HARDWARE DESCRIPTION

PART NAME: TCS Multi-Layer Blanket
PART NO: V070-361995-024 (L/H) & V070-361995-025 (R/H)
SERIAL NO: 52B51B (-024) & 52C0XX (-025)

PROBLEM DESCRIPTION

**Borescope Inspection Photo of OV-103 PRIOR to Blanket Rework
(View Looking Down and Outboard from Electrical Access Door)**

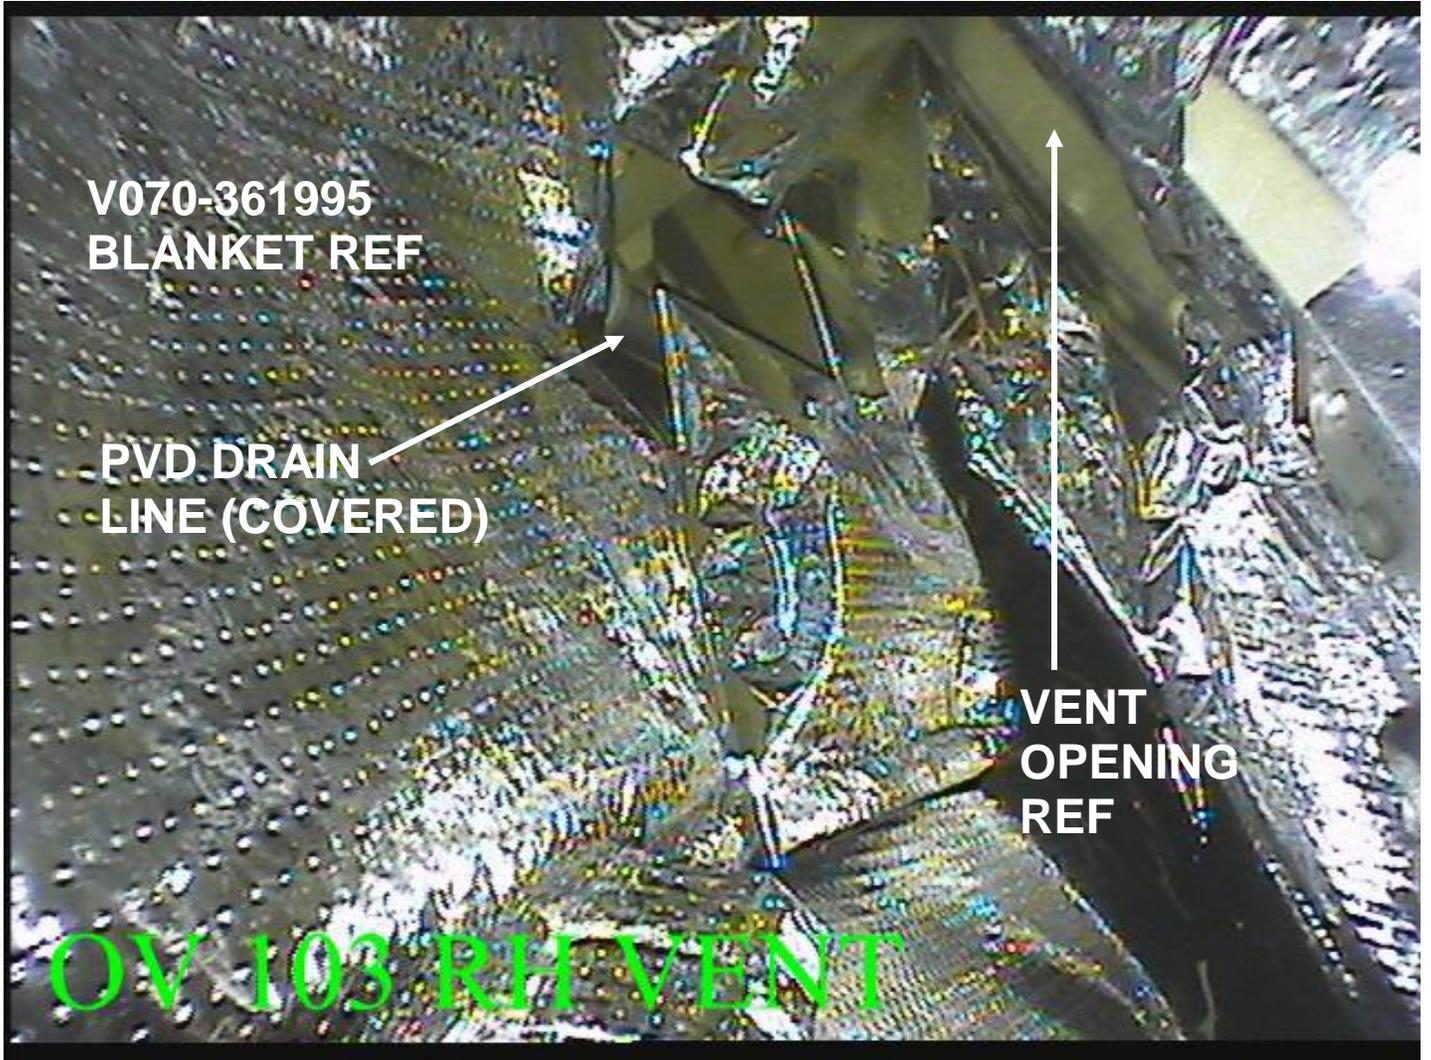
Borescope inspections on FRC3 showed that TCS blankets in the FRCS module were very close to the vents, and were not installed under PVD drain lines. Design intent is to install the V070-361995-024 (LH) and V070-361995-025 (RH) MLI blankets under PVD drain lines in the FRCS. The blankets contain existing cutouts and cutlines, allowing installation under these lines. When properly installed, the blankets are restrained by the PVD drain lines and cannot billow into the Xo 378 vent areas. Using templates to simulate a Xo378 vent port (on FRC5) TCS Engineering determined that blockage of the vent ports can occur when blankets are installed on top of the drain lines. Improper installation of the TCS blankets was determined to be the cause of the vent anomaly.

FRC3-33-1113 was written to document the problem on OV-103. CAR 121RF08 was written for corrective action. Closeout photo from STS-121 is attached, showing discrepant blanket installation.

FRC3 and FRC4 blankets were reworked and repositioned to eliminate the interference with the Xo378 vents and prevent any possibility of billowing. Blankets were installed under drain lines as per design intent, fastened to thruster box blankets with buttons and tie cord per drawing, and taped to thruster box blankets along inboard seams with approved TCS tape per Specification instructions. Post rework borescope photos show no obstruction to purge vent operation. Reference attached photo.

**Borescope Inspection Photo of OV-103 AFTER Blanket Rework
(View Looking Down and Outboard from Electrical Access Door)**

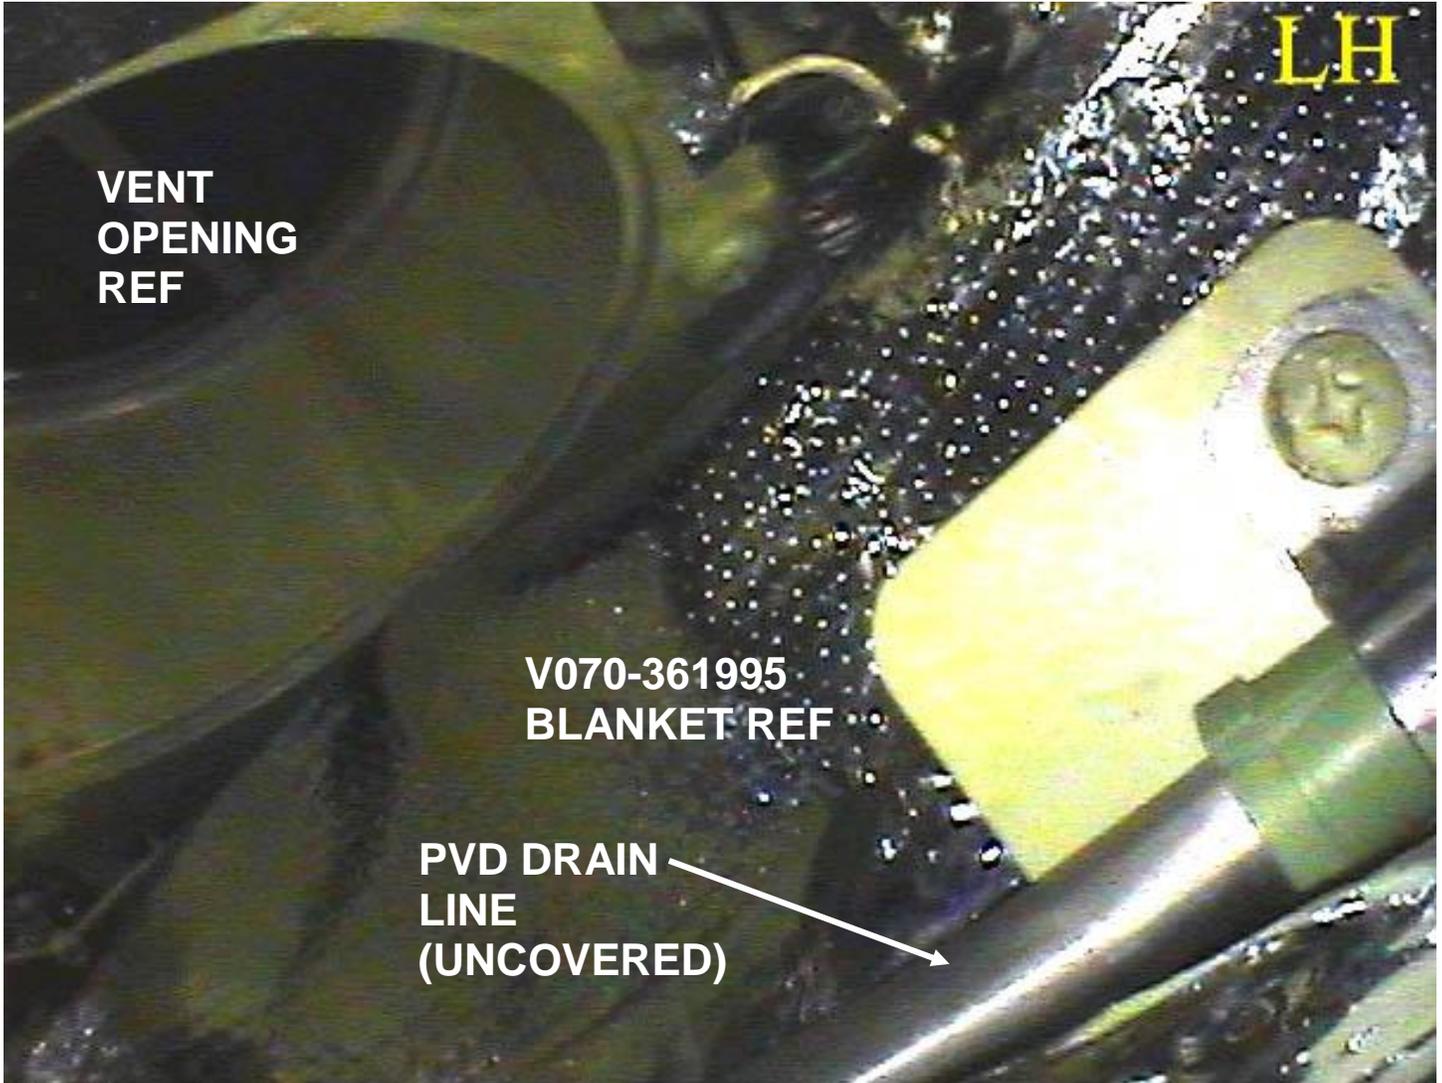
Above photos are provided for side-by-side comparison of incorrect STS-121 FRC3 blanket installation (over PVD drain line) with correct blanket installation (under PVD drain line). Correct blanket installation photo above is from FRC5 after blanket rework. OV-105 photo was chosen because FRC5 was removed, which provided clear access for photograph.

FRC5 was reworked with FRC removed. This access is preferred. FRC5 blankets were reworked and repositioned under drain lines to eliminate the interference with the Xo378 vents and prevent any possibility of billowing. Blankets were installed under drain lines per new updated drawing views, fastened to thruster box blankets with buttons and tie cord per drawing, and taped to thruster box blankets along inboard and outboard seams with approved TCS tape per drawing. Reference attached photo of blanket configuration after rework.
